## INTRODUCING THE NEWEST ENHANCEMENTS TO OUR 2019 PR- SERIES!

To Our Valued Partners:

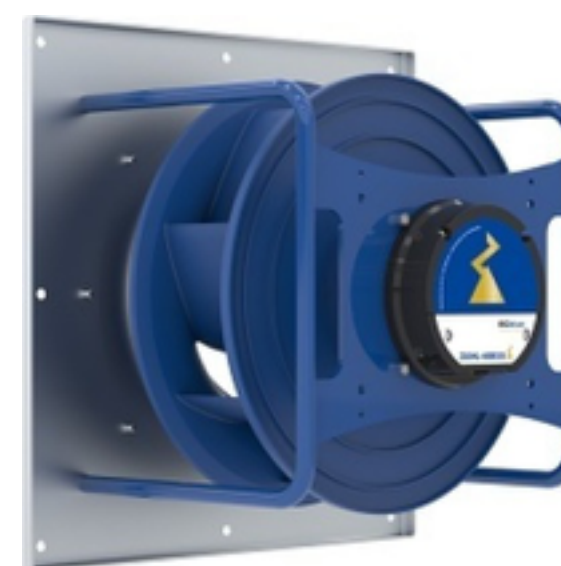
1. Microchannel condenser coils are now standard across all air-cooled models. This includes 6 fan, and 6 oversized fan D & E cabinets. These coils not only offer better performance but are also approximately 600 pounds lighter than the current tube-and-fin coils.

2. Current 280mm, 355mm, 450mm EC supply and exhaust blowers are being replaced with Ziehl-Abegg 310mm, 350mm, 450mm, 500mm, and 560mm options. These new EC blowers will be offered across the model line (where applicable) shortly.

5. All door hinges will now be full length piano-style on all cabinet configurations.
